Agenda - Final Planning and Zoning Commission

Wednesday, July 22, 2020

Public Hearing Date: July 22, 2020
Subject: Case No. SIT-2020-0048
Owners/Applicants: Rick Brenner, Property Owner/Paul Mifsud, Applicant
Case Manager: Ryan Foster, AICP, Principal Planner

Case No. SIT-2020-0046:

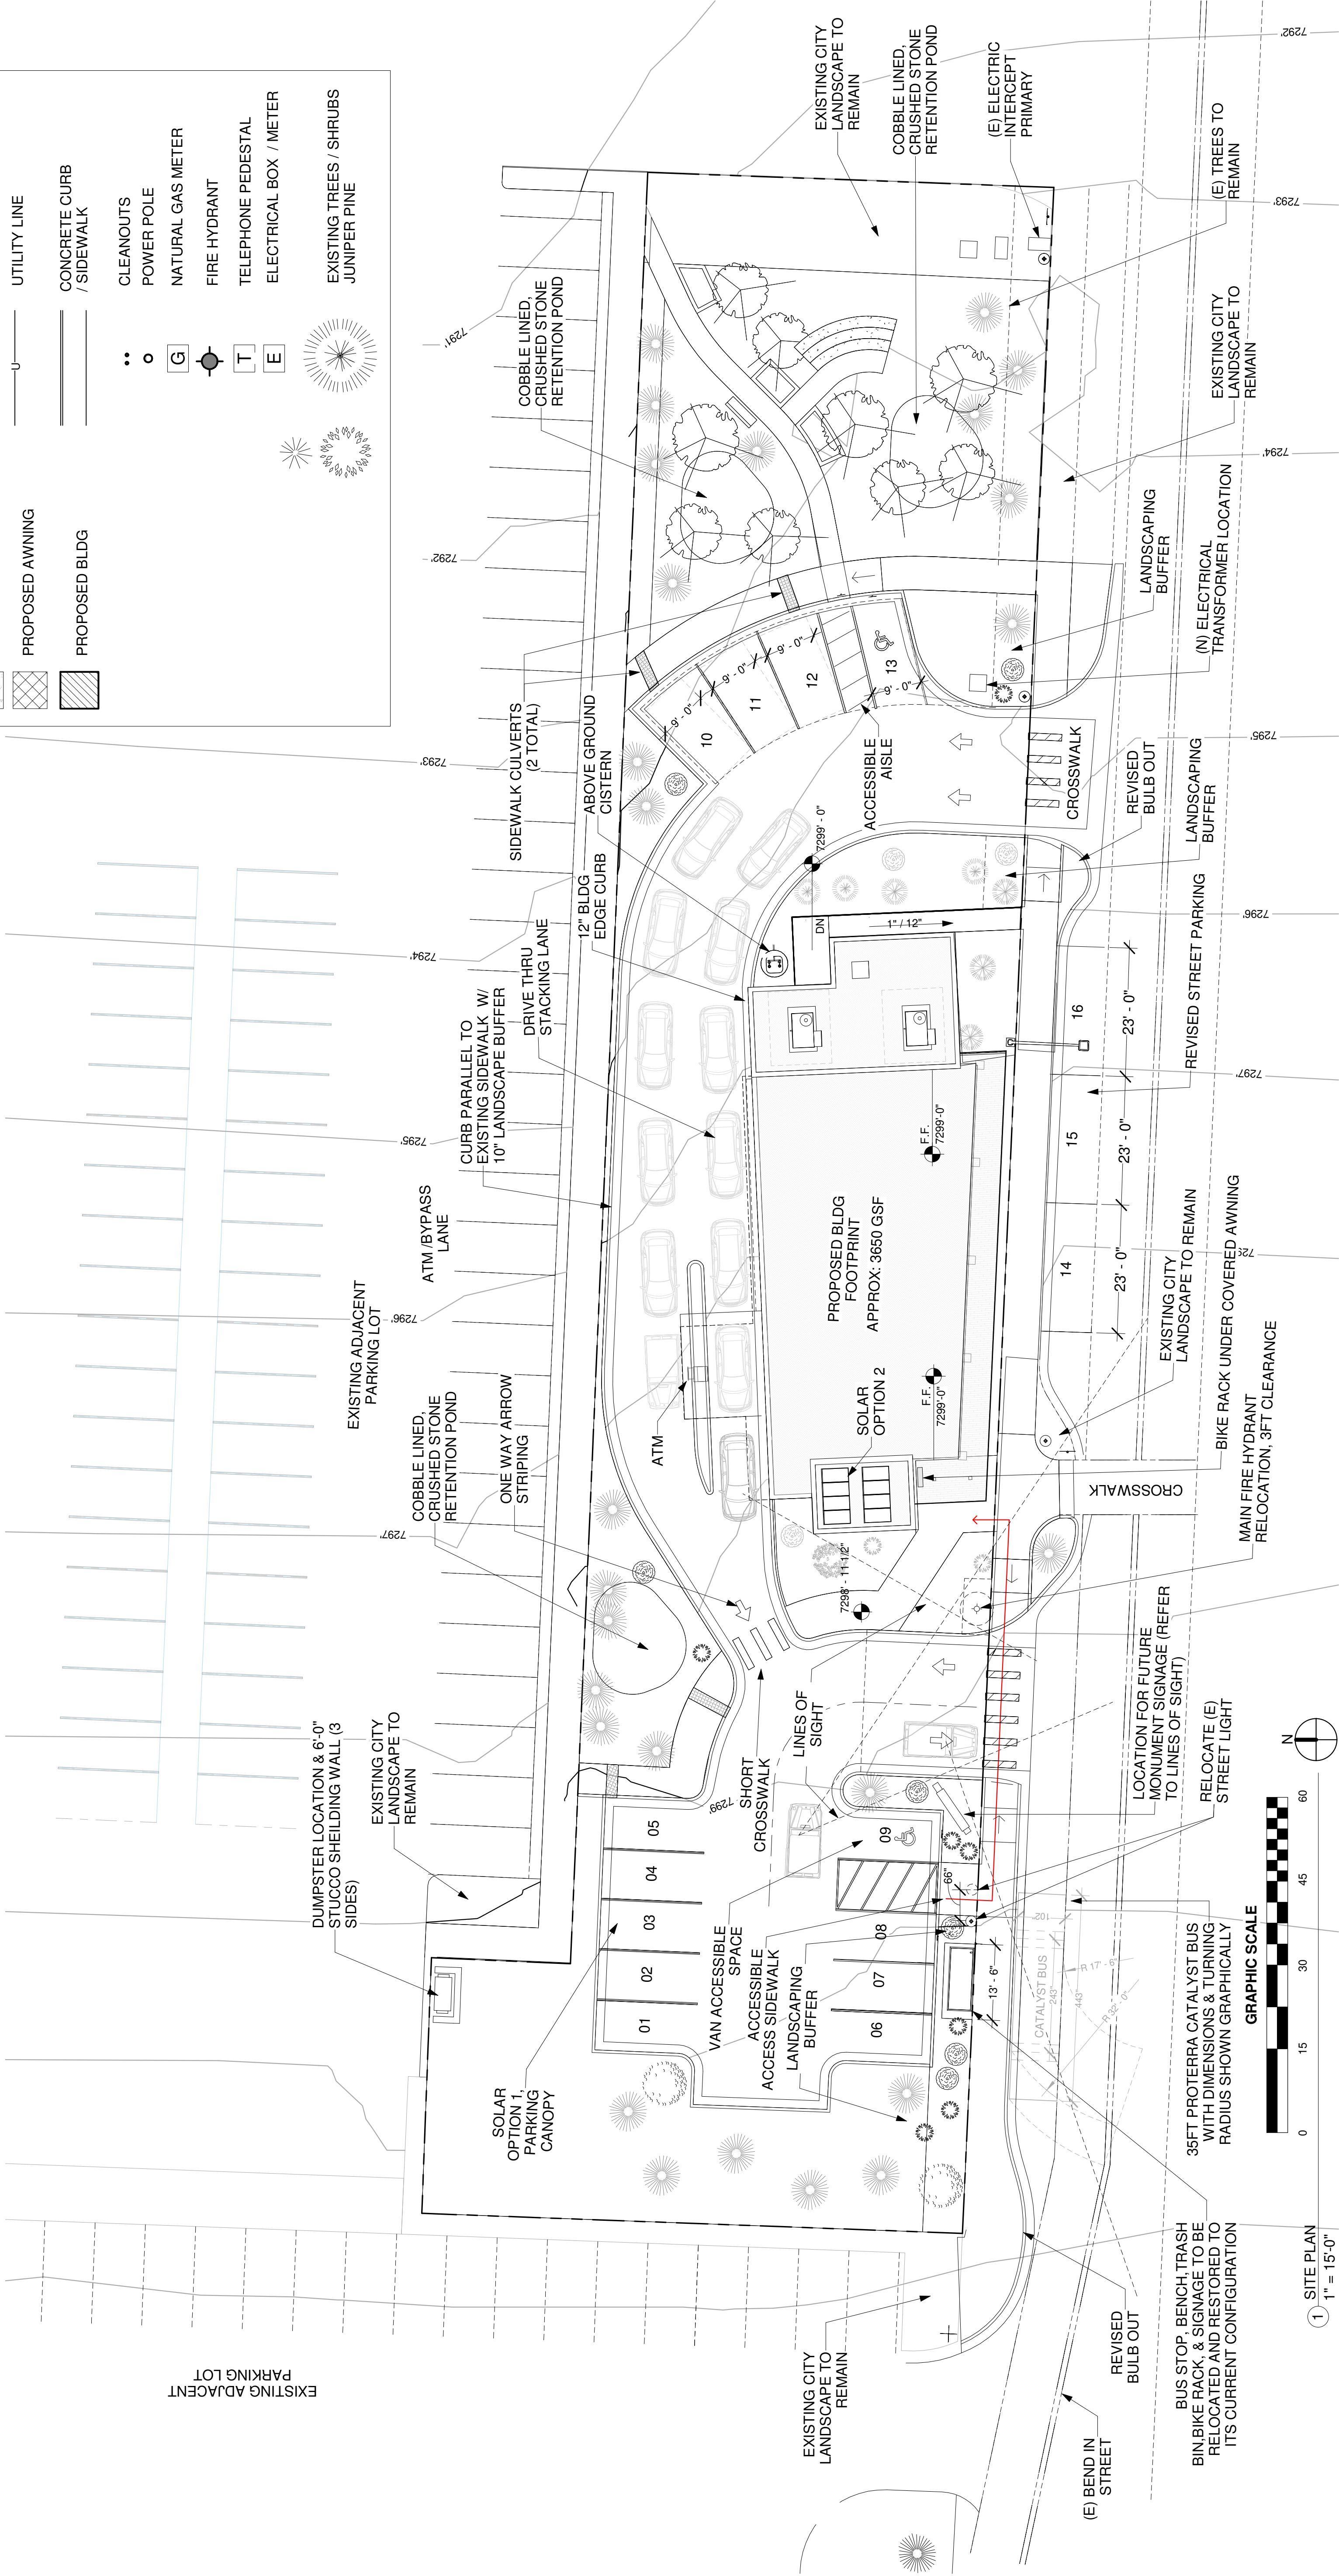
3. Per Public Works, Streets Division: A comment regarding the placement of the last parking space (#14 on the site plan) being too close to the eastern entrance. Perhaps this could be moved next to parking space 5, if needed.

4. Per Public Works, Streets Division: Provide a sidewalk connection from the eastern parking area through the landscape buffer, to the building. Especially if the only ADA space is in the eastern parking area.

5. Per Public Works, Streets Division: Perhaps the 3ft. space next to the ADA space can be swapped to get it farther from the driveway entrance.
6. Per Department of Public Utilities: The utility plan does not show the electric service. This needs to be added to the utility plan. See attached comments from prior submittal regarding electric service connection.

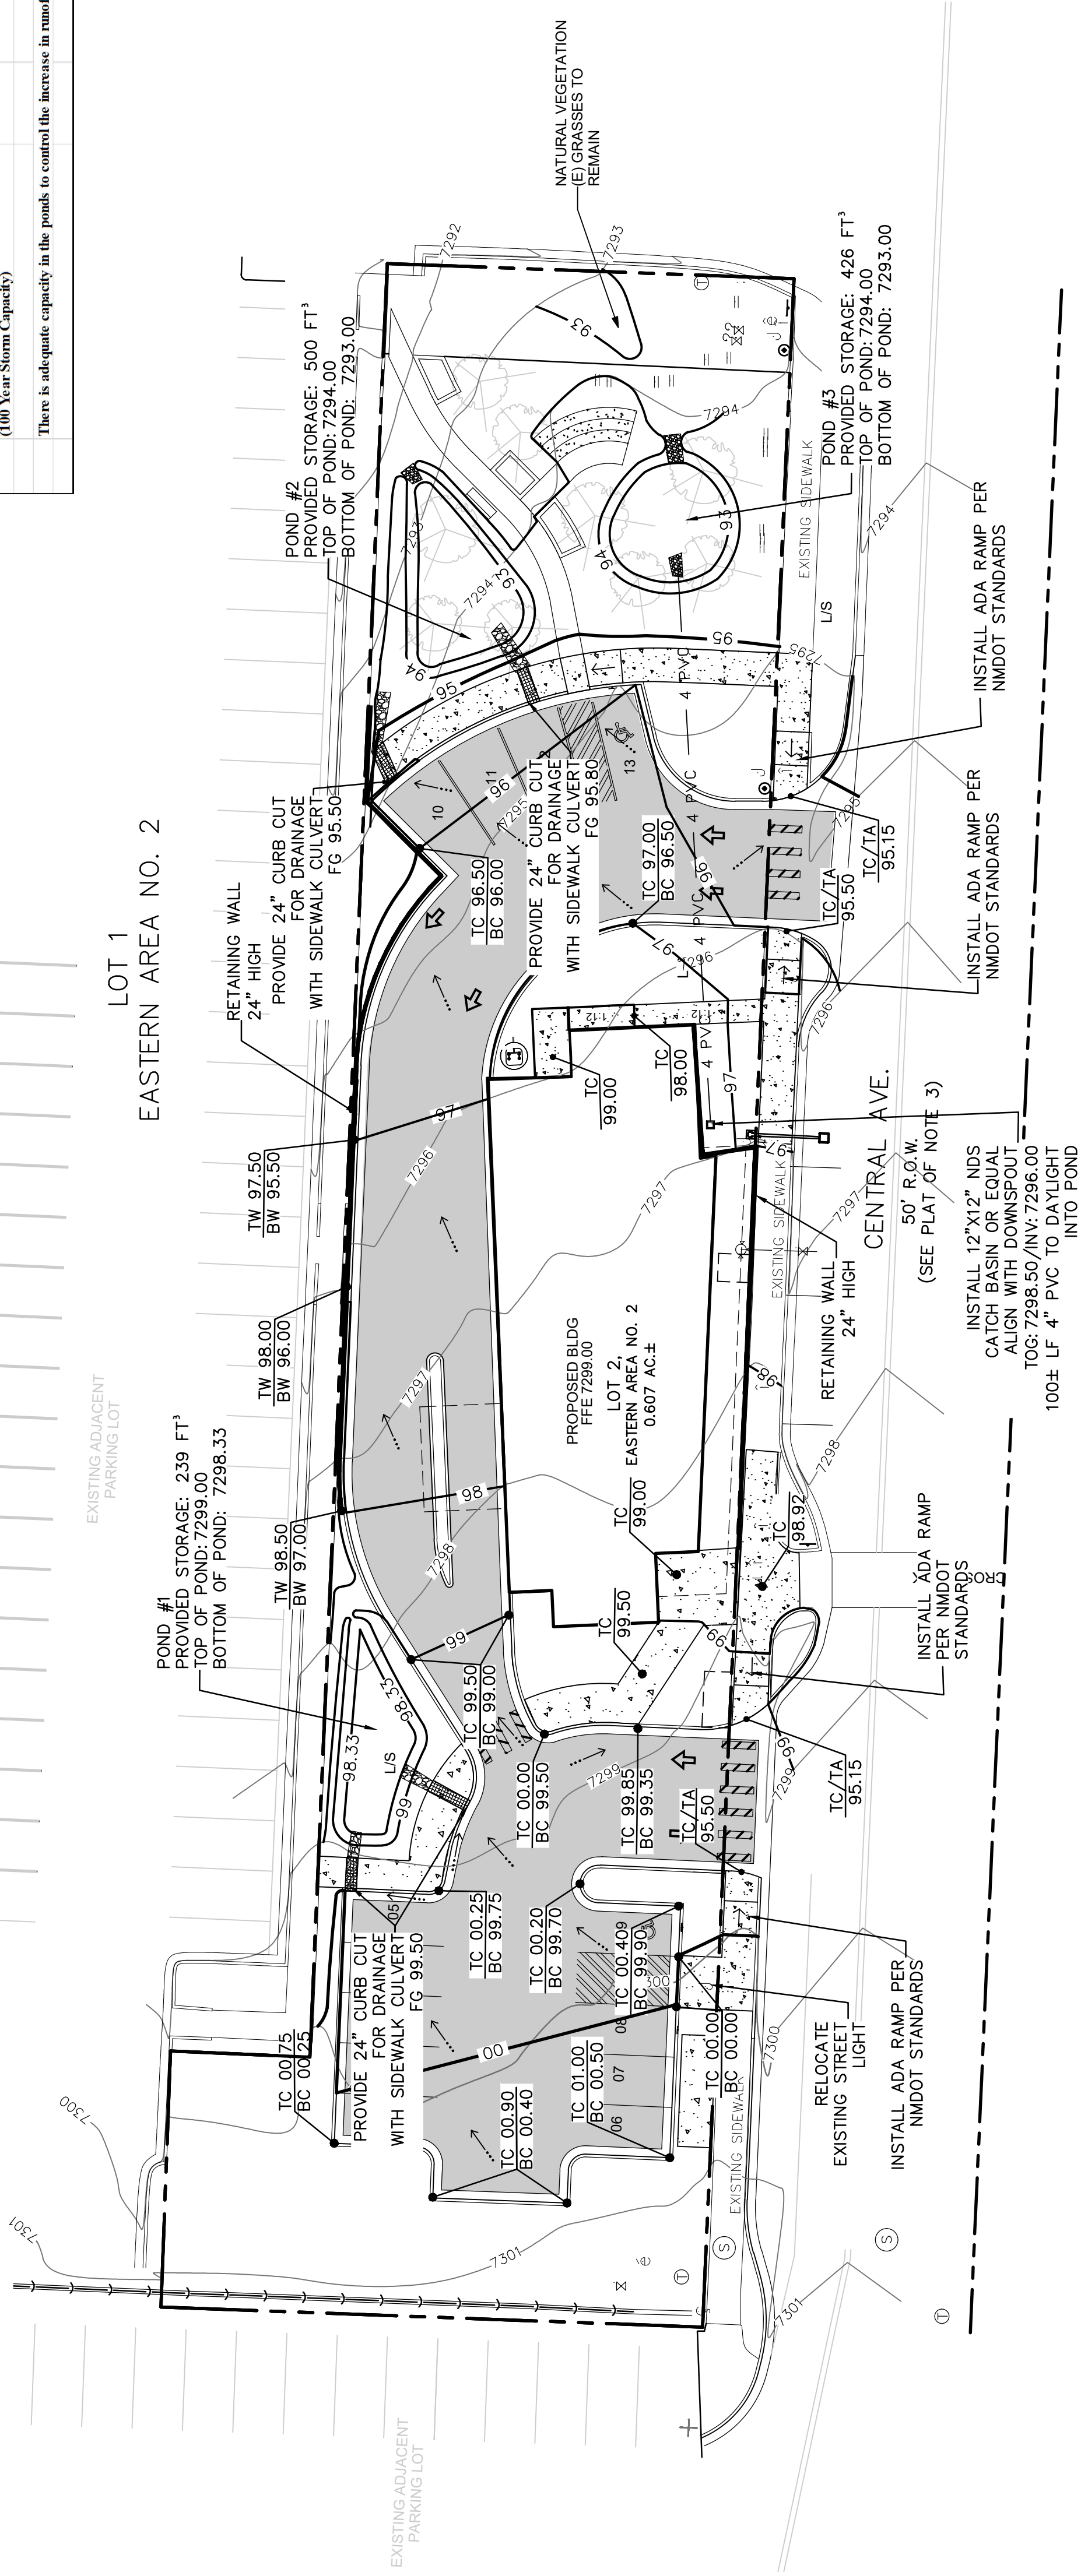
- Condition #2. Per County Engineer, Public Works: Update the Grading & Drainage Plan in coordination with the Public Works Department to include:
 - Additional detail for storm water to reach proposed outfall/ponding areas, i.e. additional flow patterns, curb cuts, sidewalk culverts, drain inlets, etc. and clarify elevations shown.
 - Provide a statement on the plan to indicate that the drainage design meets the requirements of the County's Public Works Design & Construction Standards.

Applicant Response: Storm water drainage shall be coordinated with county engineer and be in accordance with the County's Public Works Design & Construction Standards. On-site drainage will be directed to aesthetically pleasing on-site drainage ponds. Ponds are sized for the increase of runoff for the additional impervious area. Drainage structures will be design as required by the County's Public Works Design & Construction Standards. See Exhibit E Grading and drainage plan.

PROJECT: LOS ALAMOS SCHOOL CREDIT UNION	SHEET TITLE: OFFSITE IMPROVEMENT PLAN
--	--

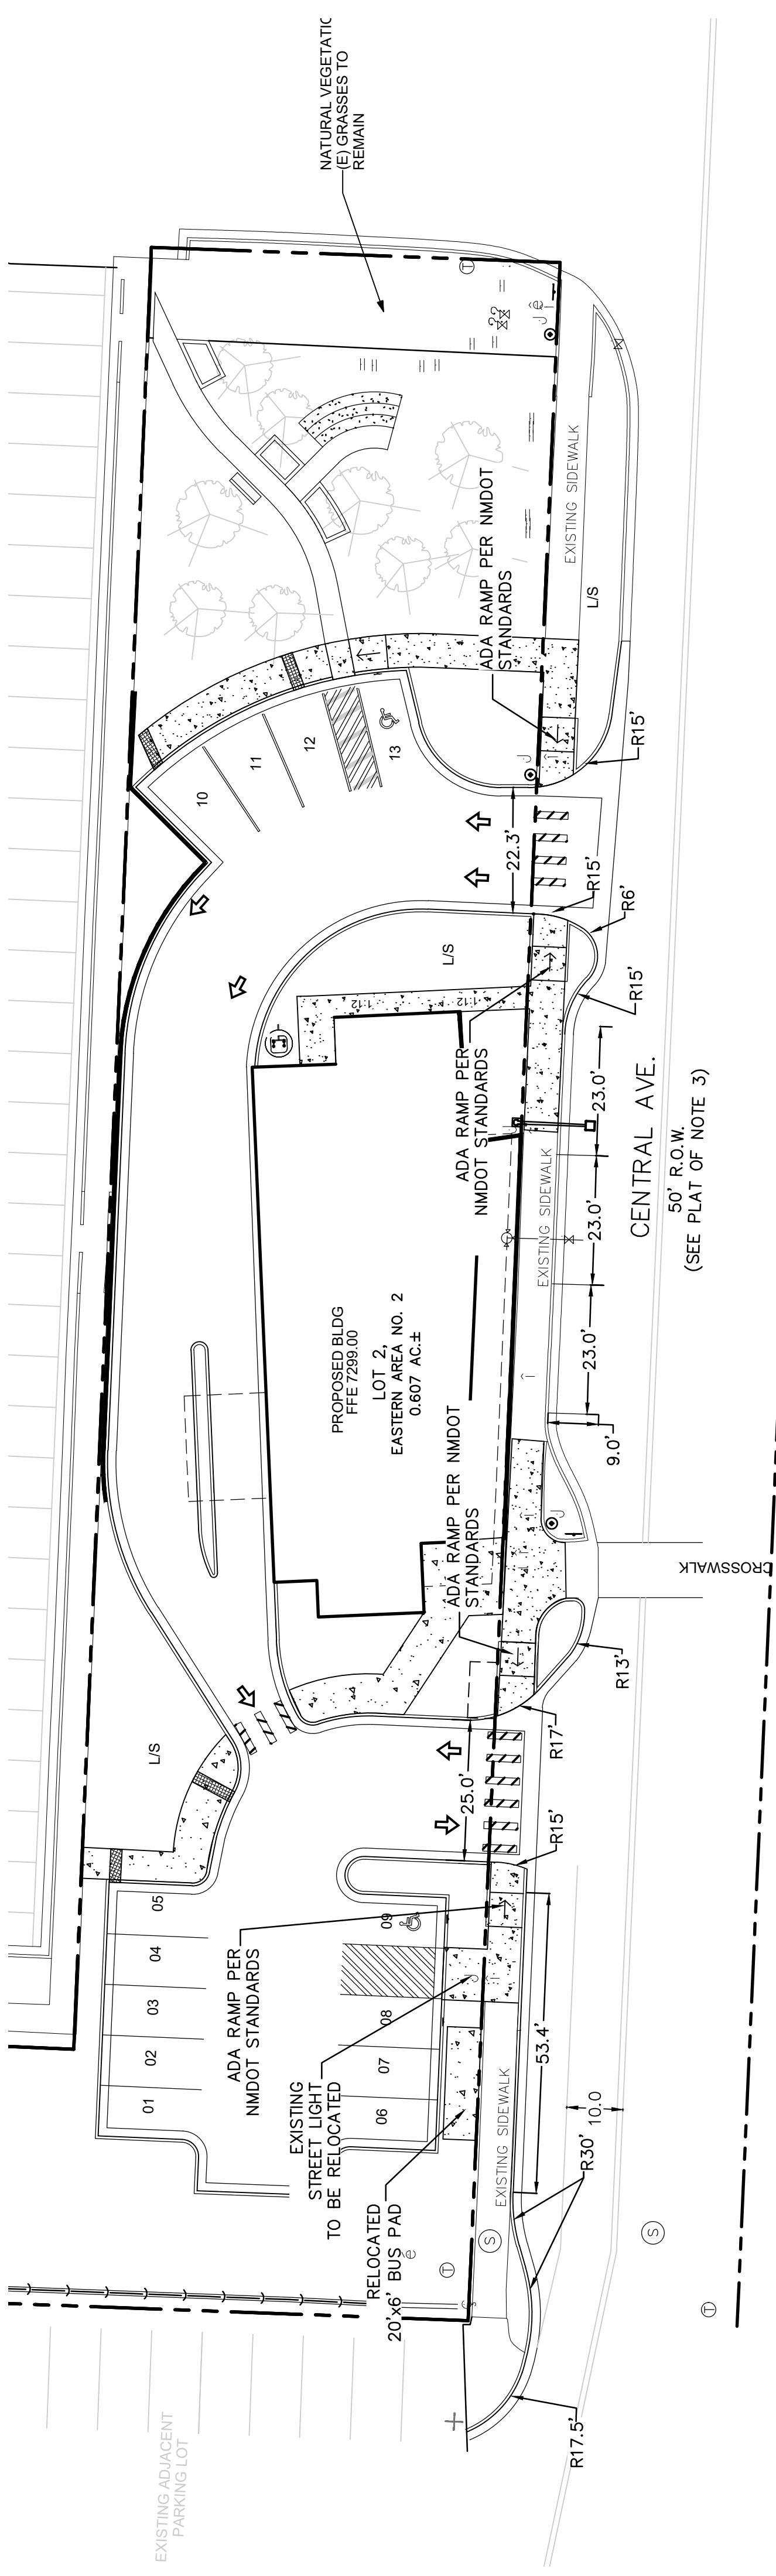
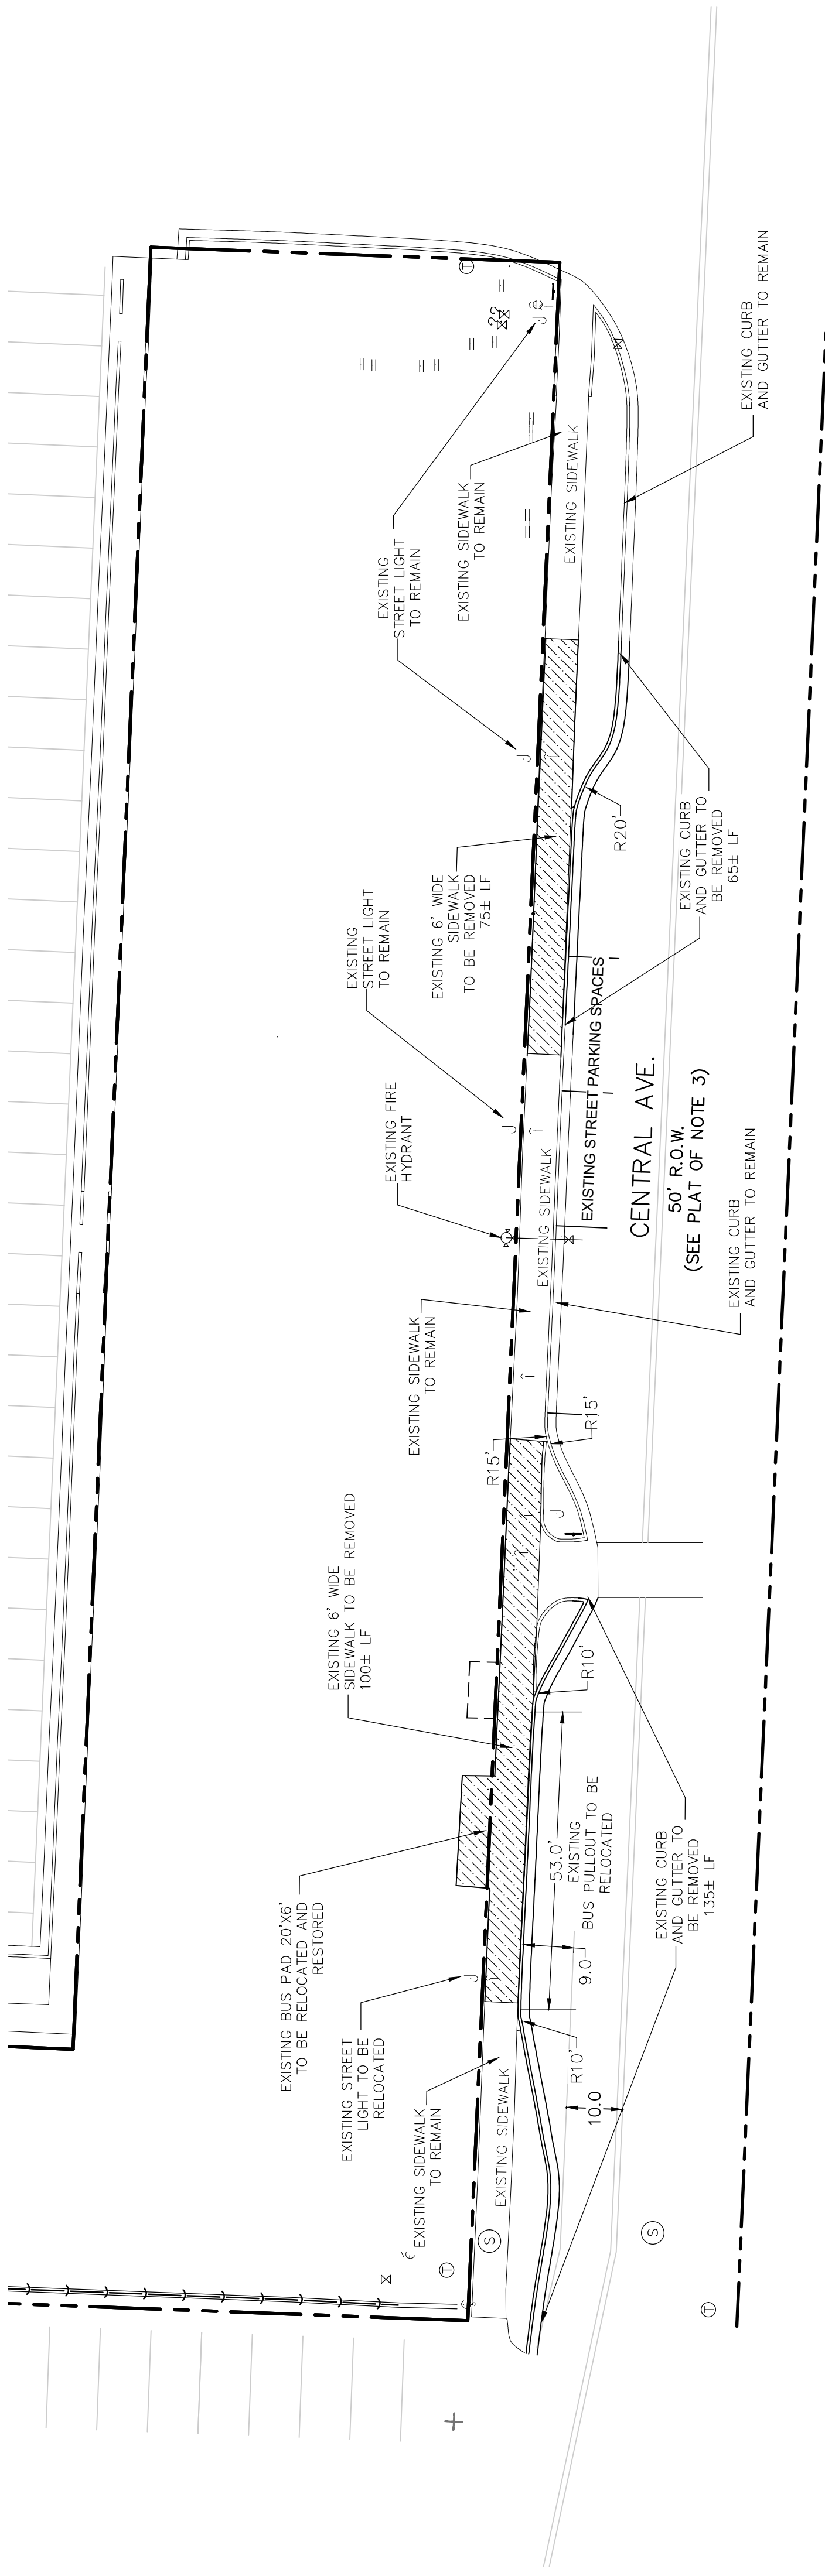
- **Condition #3 Per County Engineer, Public Works:** Update and provide additional geometric design details of the bus pullout lane and both driveways in coordination with the Public Works Department to include:
 - Exiting taper/reverse curve design of the bus pullout lane
 - Removal of the western bulb-outs at each driveway.
 - Provide a note that the bus pad will be relocated and restored to its current size and configuration including all appurtenances, i.e. bench, trash bin, bike rack and signage.

The geometric design details of the bus pullout lane have been incorporated in this application. The bus stop platform and pullout lane have been shifted to the west in order to accommodate the proposed site plan.

BUS PAD SHALL BE RELOCATED AND RESTORED TO ITS CURRENT SIZE AND CONFIGURATION INCLUDING ALL APPURTENANCES, I.E. BENCH, TRASH BIN, BIKE RACK AND SIGNAGE
